**CITY OF HANOVER  
PLANNING COMMISSION MEETING  
MARCH 26, 2018  
AGENDA**

Date: March 26, 2018  
To: Planning Commission  
From: Cindy Nash, City Planner  
RE: Hanover Dental – Site Plan

**Re:** *Hanover Dental Plan Review*  
*WSB Project No. 011692*

GRADING PLAN

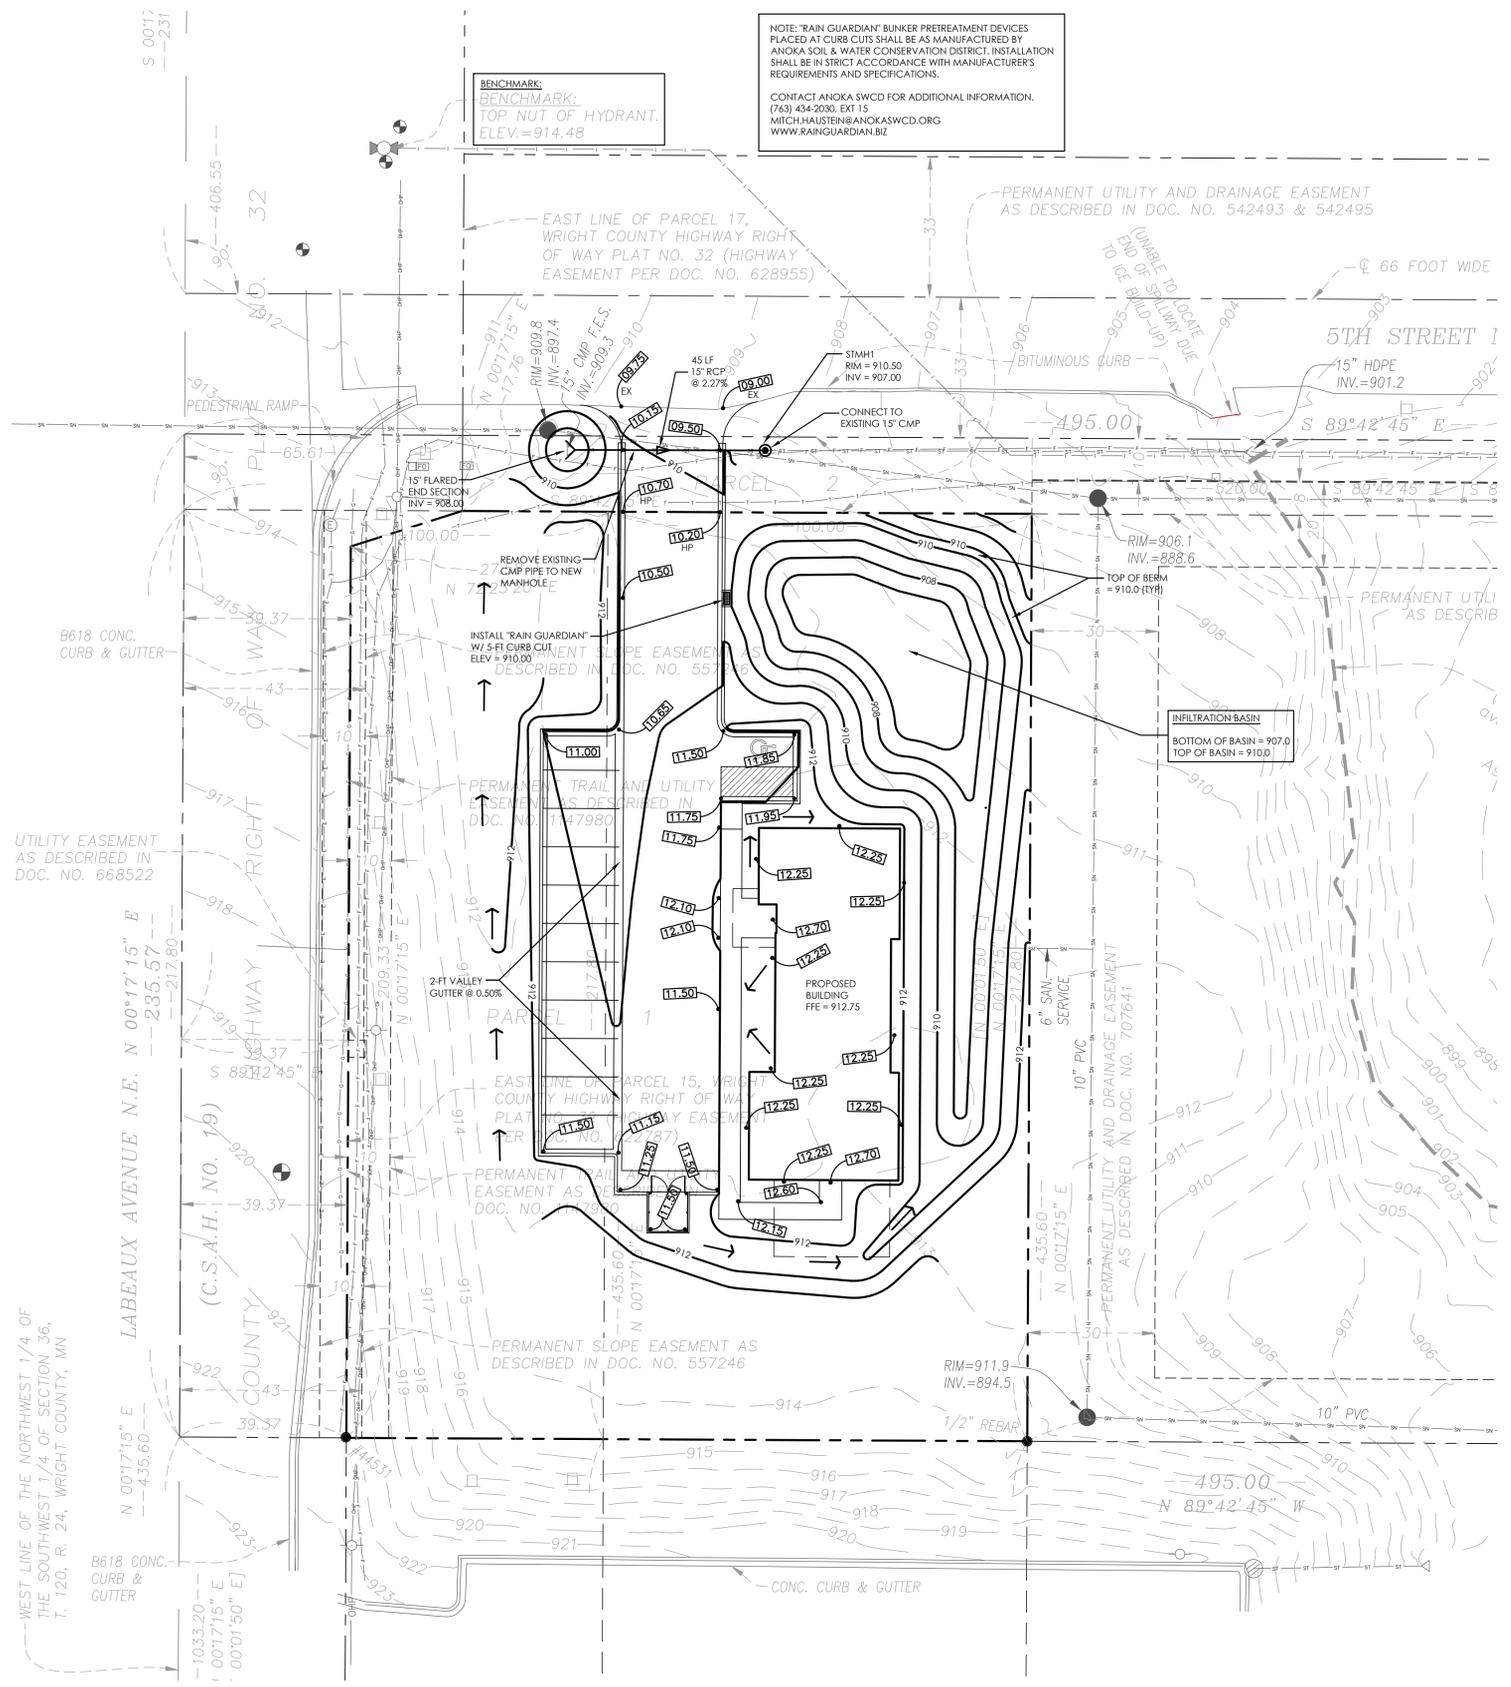
2. Install a commercial concrete driveway apron per City standard detail STR-08.
3. Extend the curb coming from Labeaux Avenue through the proposed driveway and tie in to the existing bituminous curb on the east side.

4. Install a 2'x3' catch basin in the curb line just to the west of the driveway apron per City standard detail STO-01.
5. Connect the 2'x3' catch basin to a 24" high beehive structure where the current FES inlet is located on the west side of the driveway is proposed.

6. Regrade the swale on the west side of the parking area to achieve the minimum grade (2%) requirements to the proposed beehive structure.
7. The areas up against the south and west sides of the building do not meet minimum grade requirements. Provide any additional gutters or drains being proposed to direct drainage.

10. The drainage just north of the driveway/parking area is shown flowing to and along the west edge of the driveway and then transitions to flow across the driveway to the raingarden along the east edge. Provide how would this transition would work.

C-102

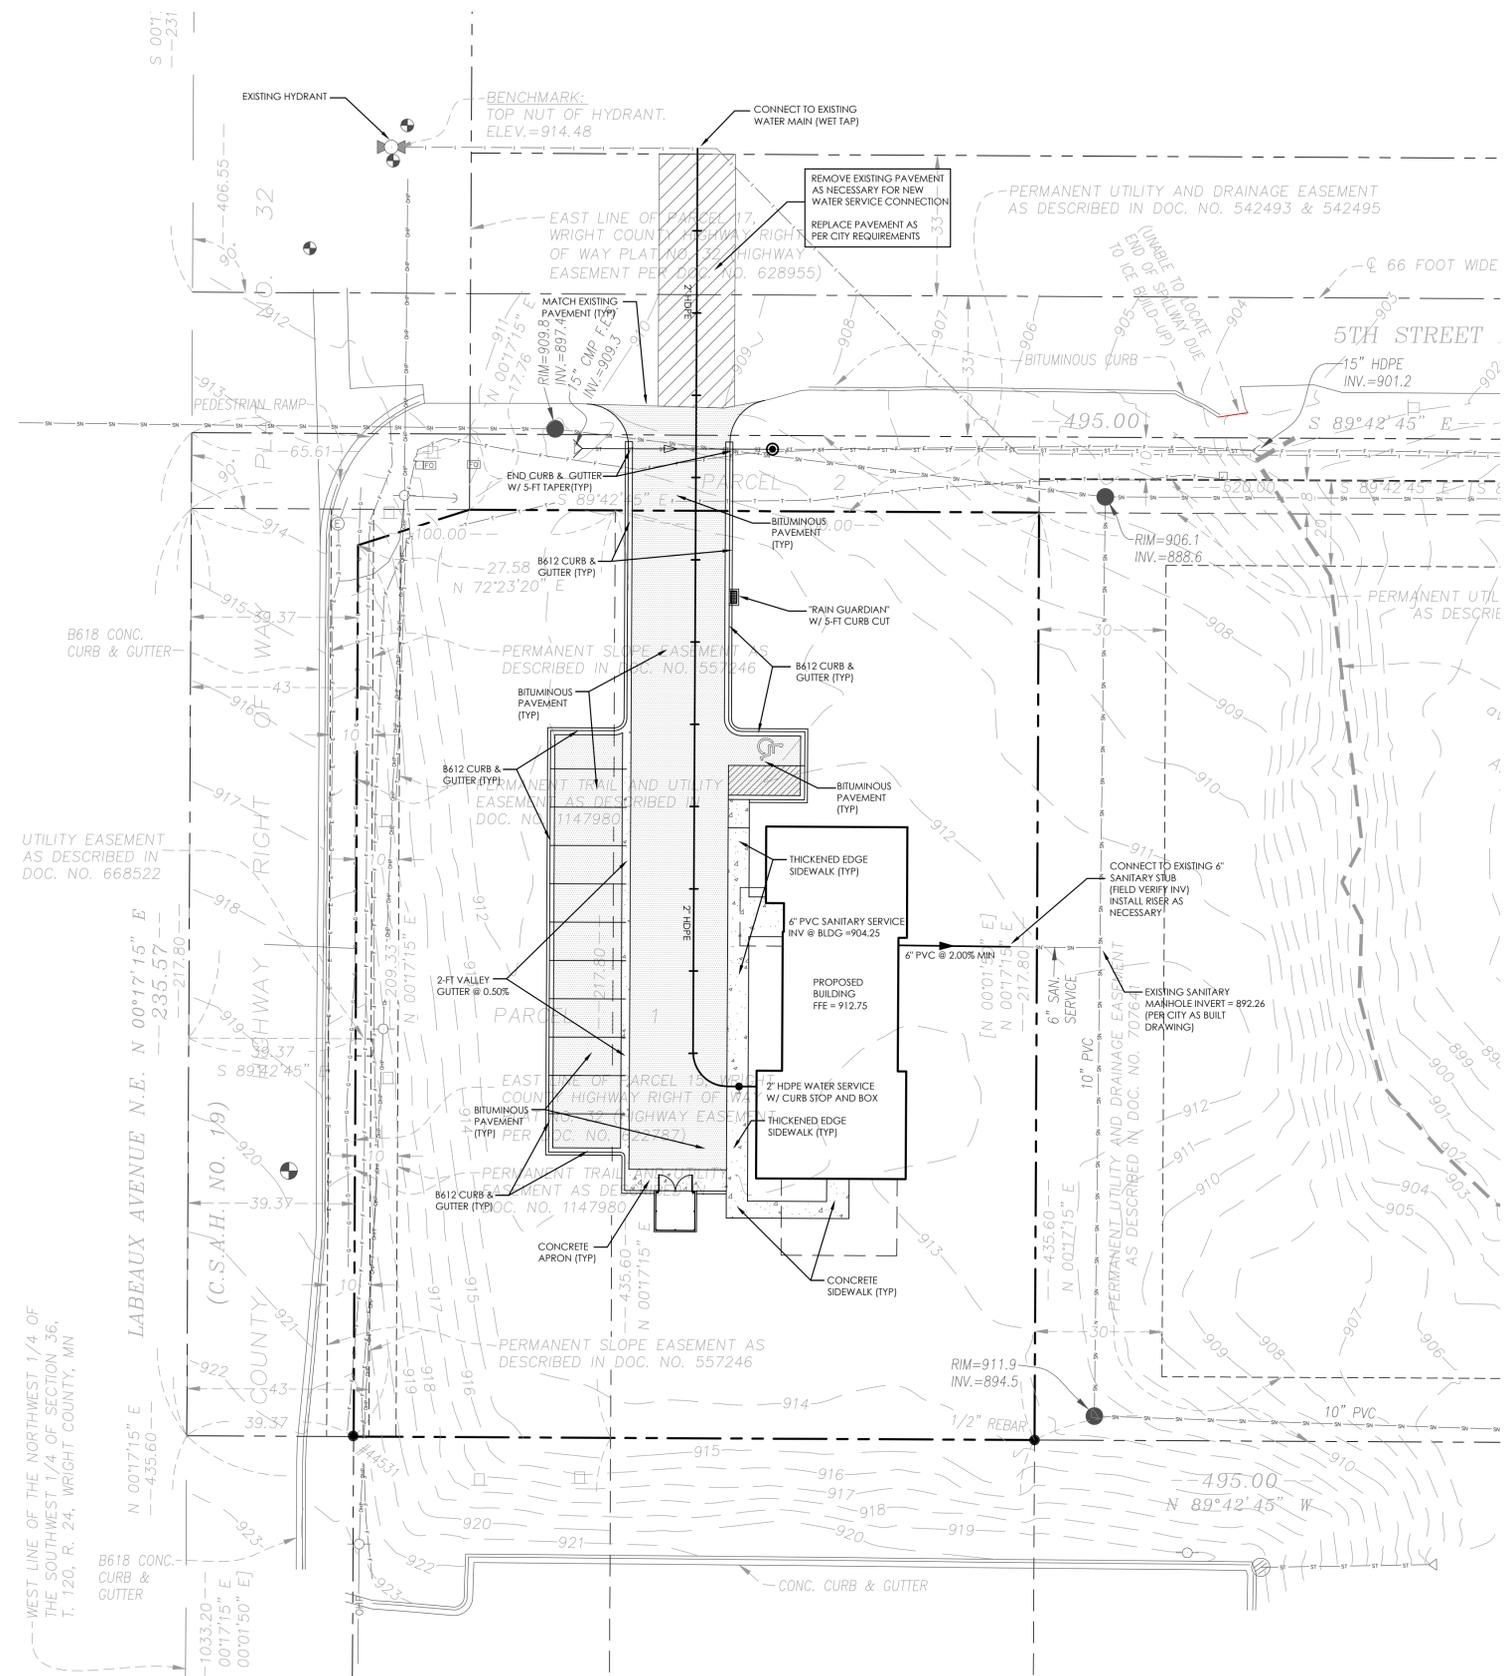
11. The service connection to the watermain should occur at a point on the south side of 5<sup>th</sup> Street.
12. There is an existing 6" water service stub with shut off valve located on the south side of 5<sup>th</sup> Street in front of Parcel 2 to the east that can also be utilized.
13. Any other connection should be made per City standard detail WAT-04. Copper pipe should be used from the connection at the watermain to the curb stop.
14. The proposed storm manhole should be shifted to the east so as to not impact the existing sanitary sewer main.
15. Remove the word 'manhole' from the label for the existing invert elevation of the sanitary sewer service stub at the main on sheet C-102 which seems to imply a structure exists at the junction.
